GROVE & DALL'OLIO
ARCHITECTS PLLC

Addendum #3

To:	General Contractors	From:	Lisa Dall'Olio
Attn:	Estimating Departments	Pages:	3 plus attachments
Fax:		Date:	11/1/2021
Re:	Claggett Center Barn

Claggett Center Barn Renovation

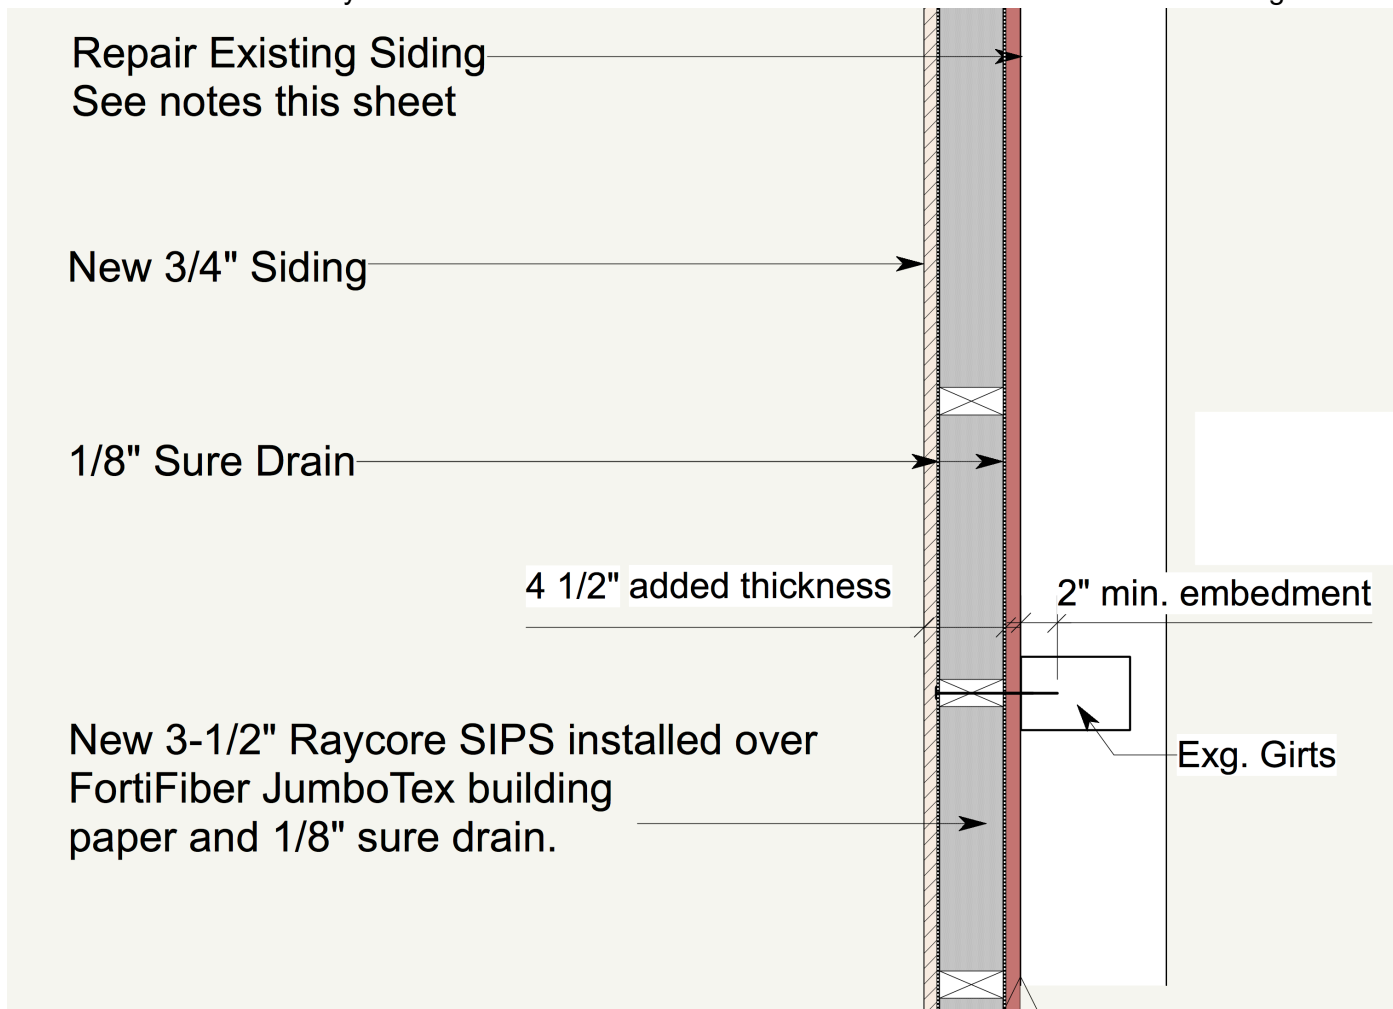
- 8) The option of using SIPS on the exterior has been further explored. Please include in your pricing the add/deduct option to replace the proposed double layers of rigid wall insulation and nailers with 3-1/2" RayCore SIPS run horizontally(see below detail). The Upper Level Plan has been revised and is attached. It correctly shows the additional thickness of the exterior insulation and new siding.

A7.2

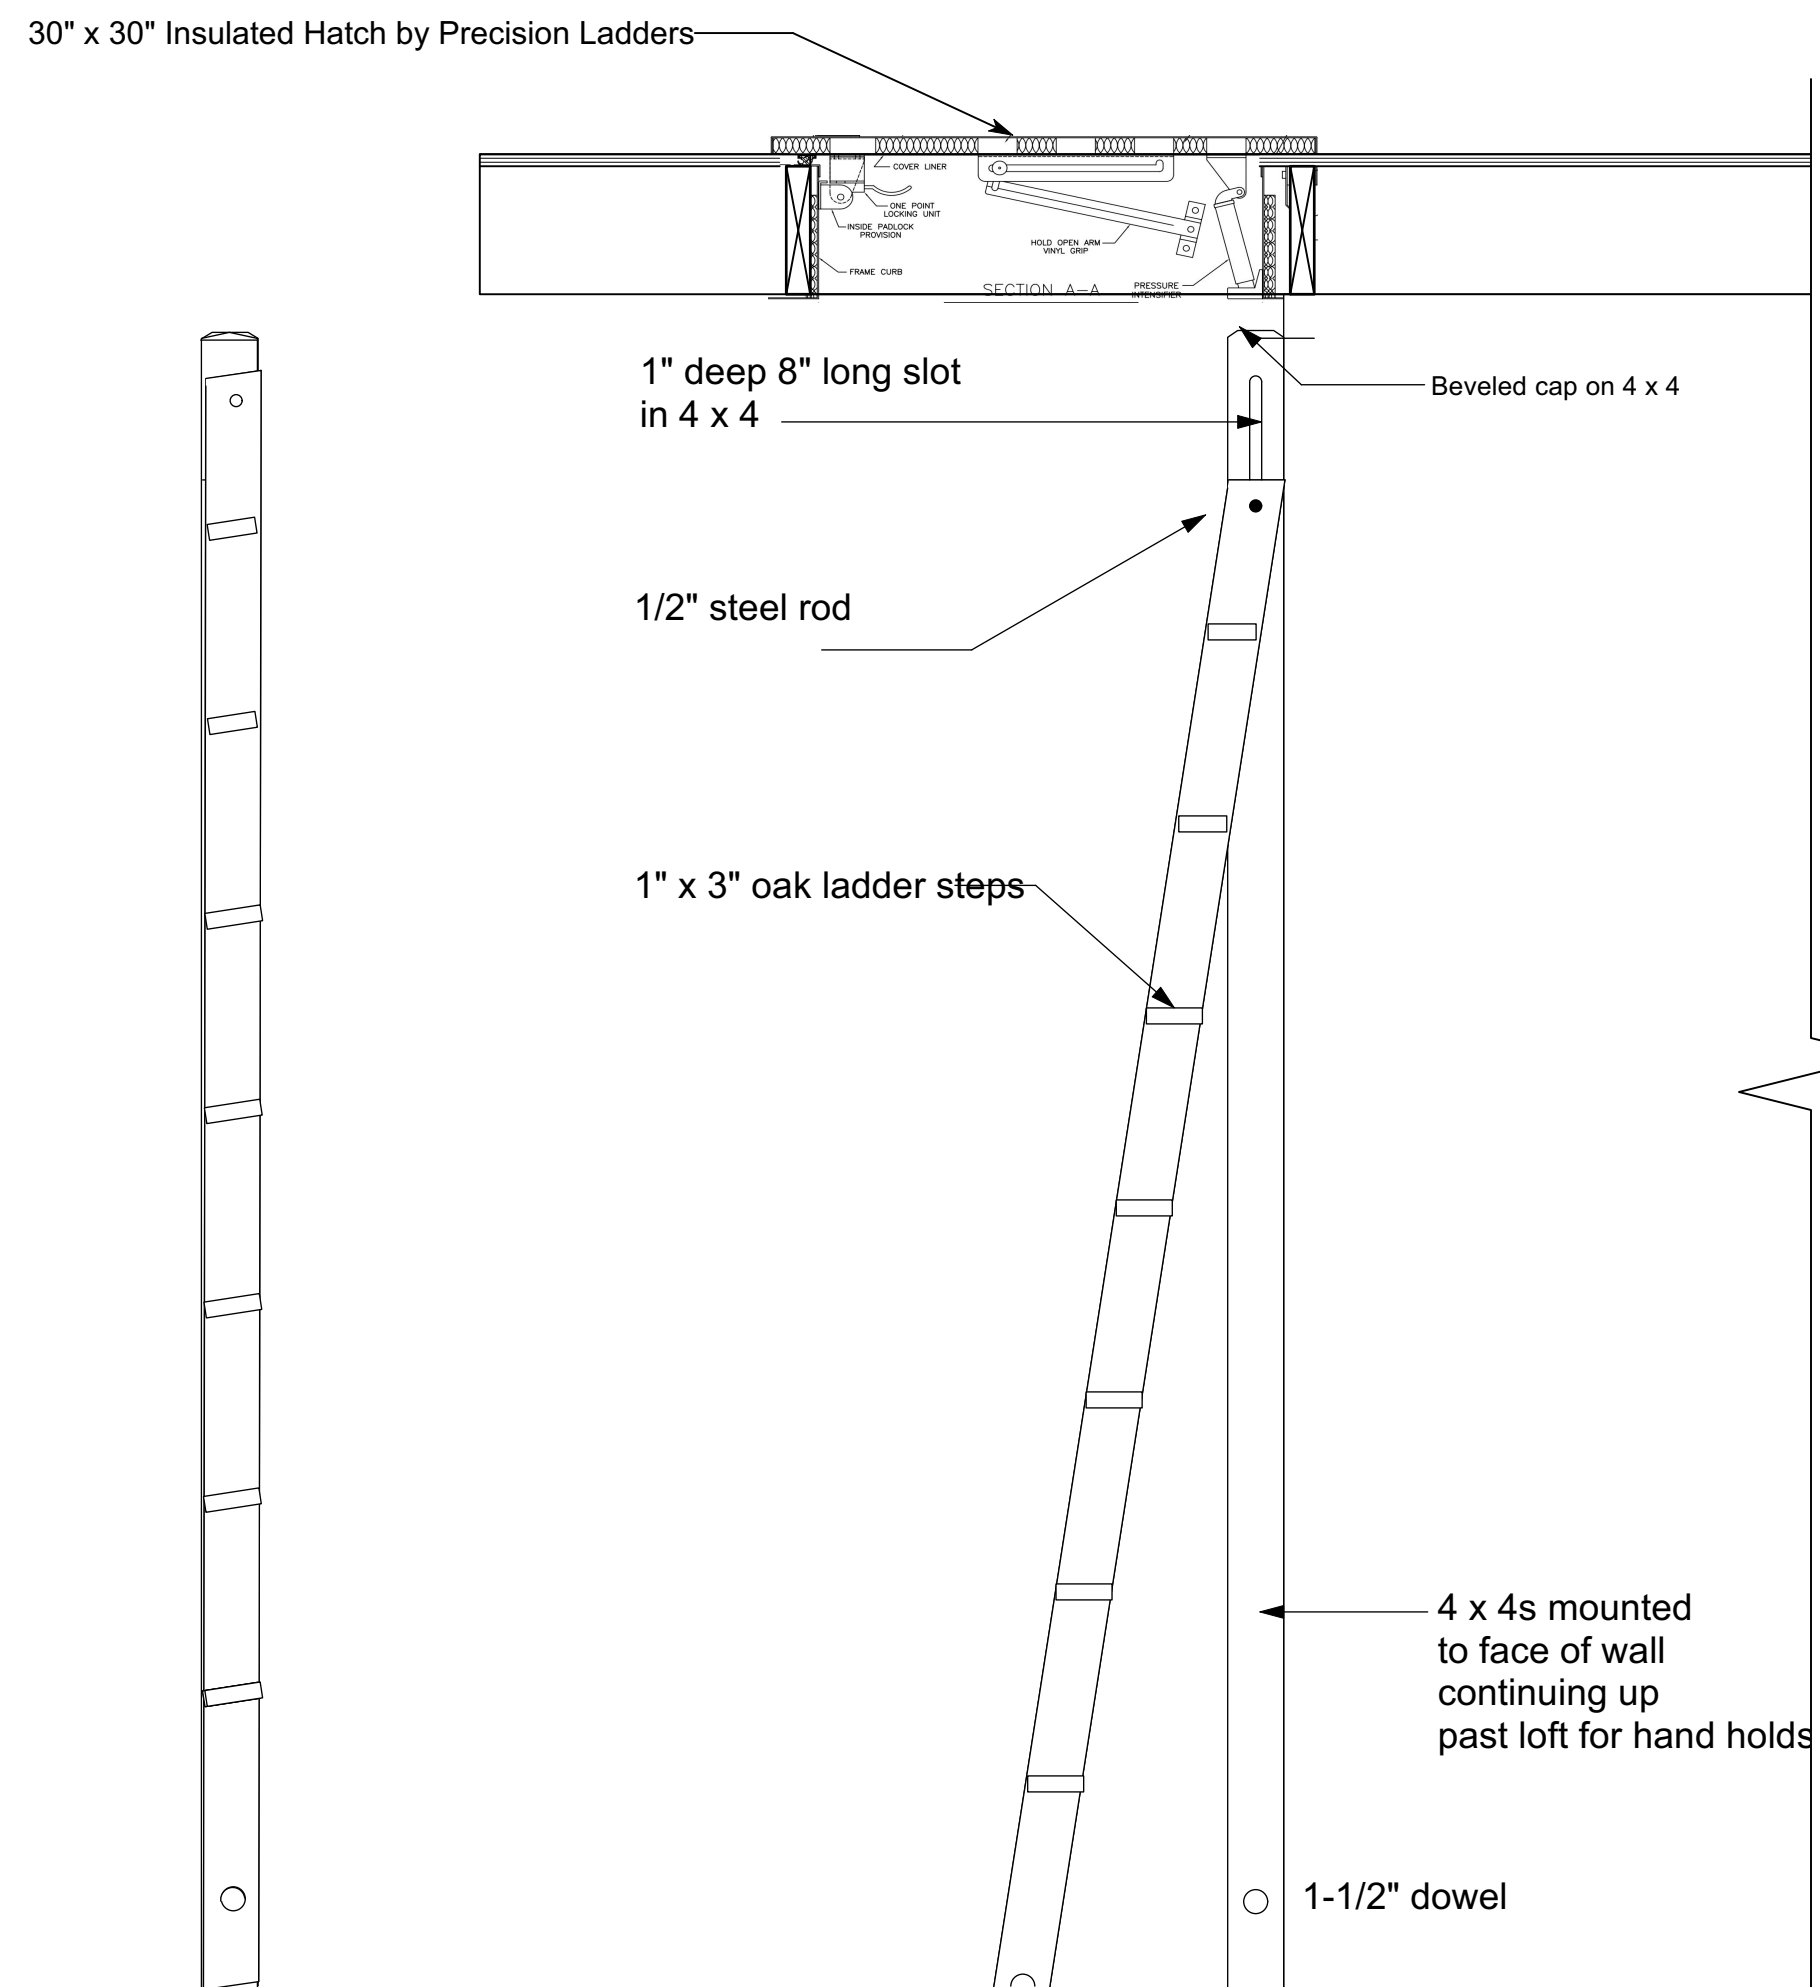
- 9) The Form of Proposal has been revised to include unit prices and the above add/deduct option. It is attached for your use.
- 10) The stair railing details have been revised to meet ADA requirements and to provide a code required guard. The revised detail is shown on the attached revised Sheet A7.2.

8 Retaining Wall Detail
Scale: 1" = 1'-0"

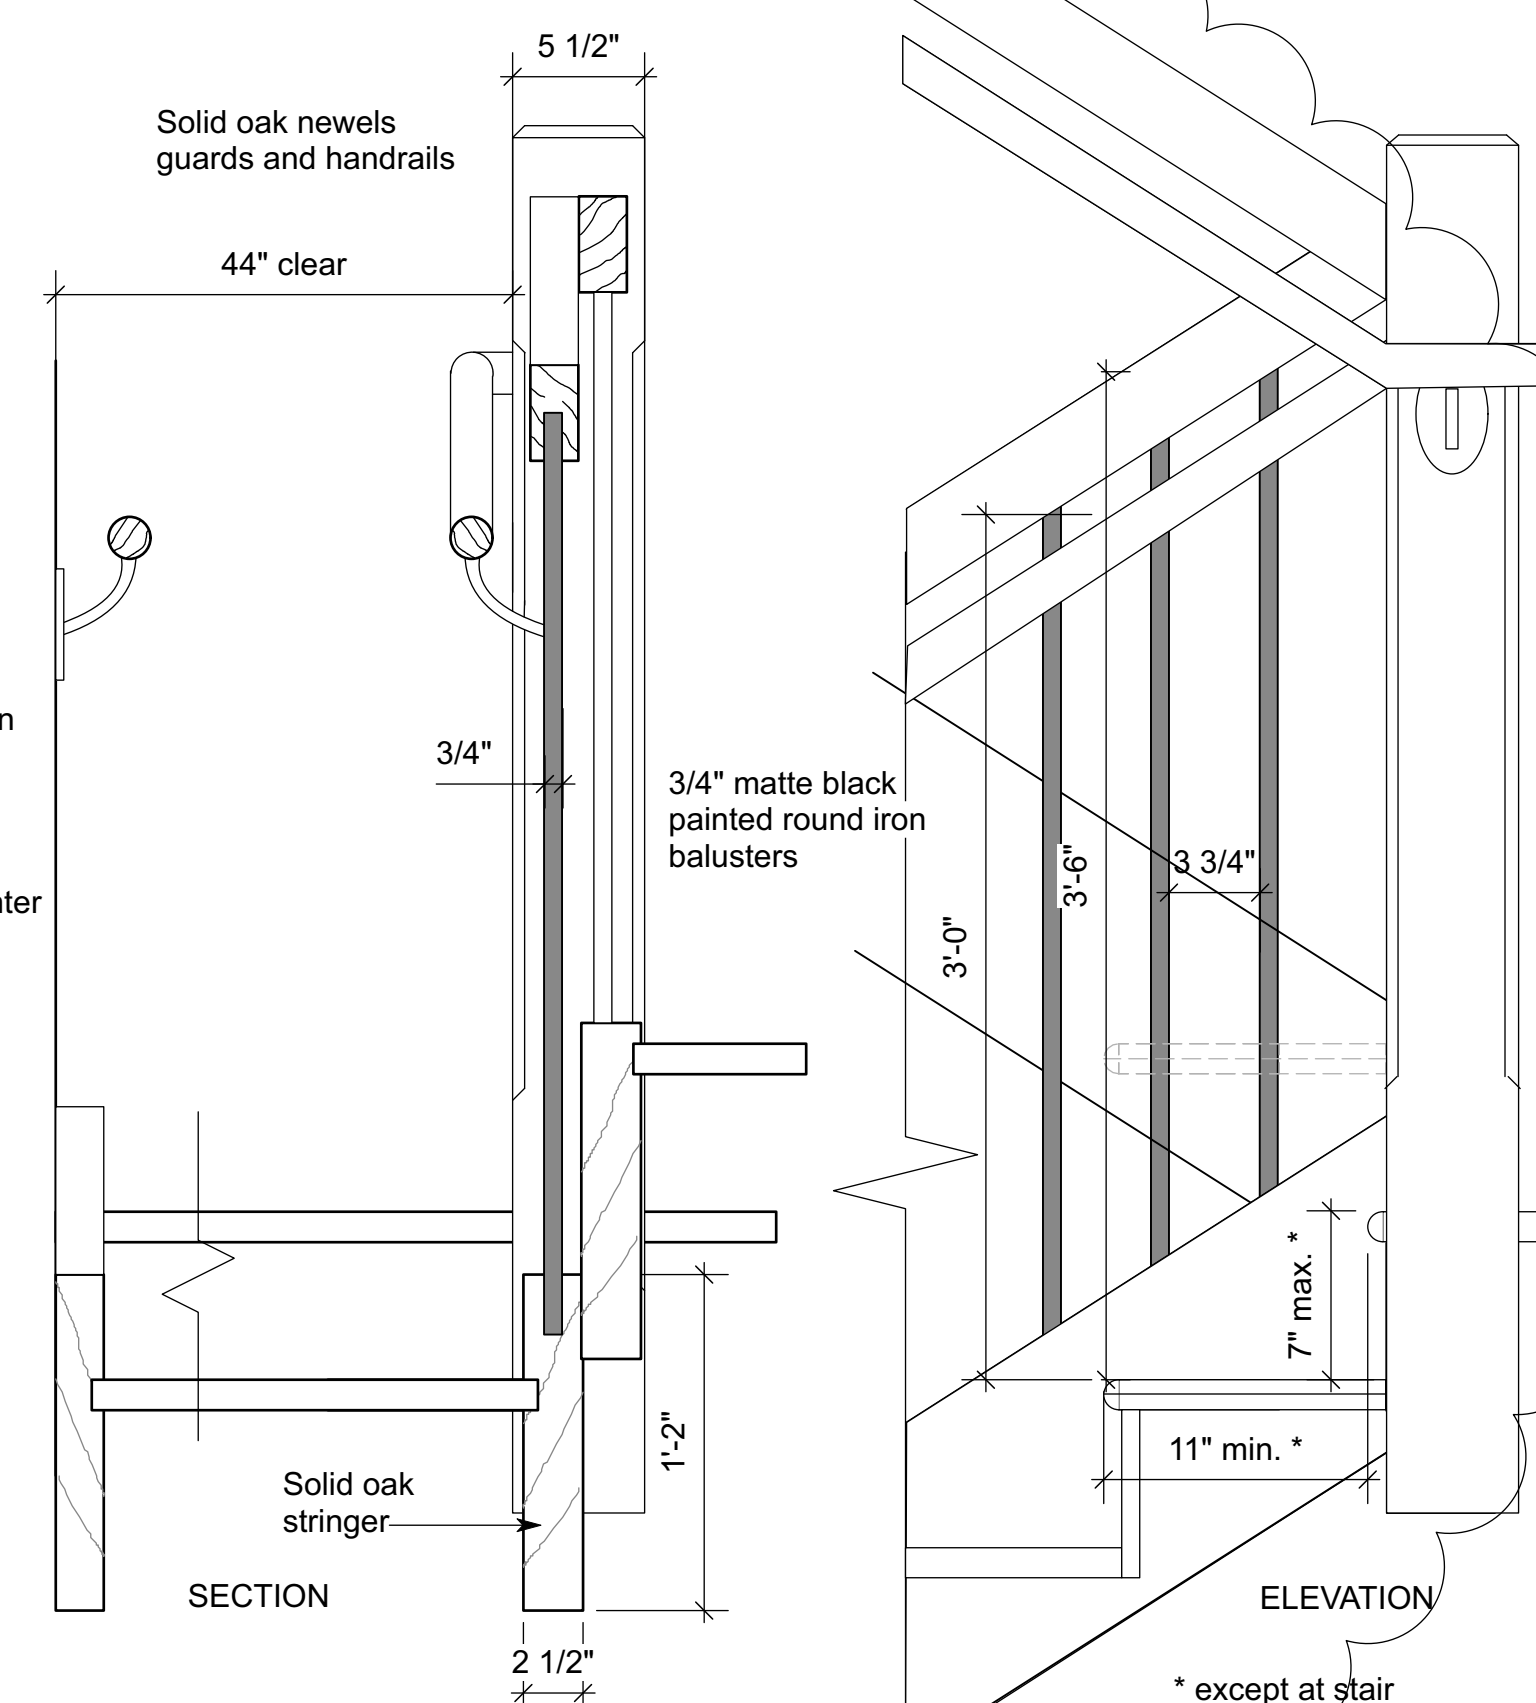
- 1) Retaining wall detail on A7.2 shows 5' max. height for 20" wide wall. Retaining wall design and reinforcement details are not on the structural drawings. Are the details available somewhere else?
- 2) Answer: The revised detail is shown on the attached revised Sheet A7.2.
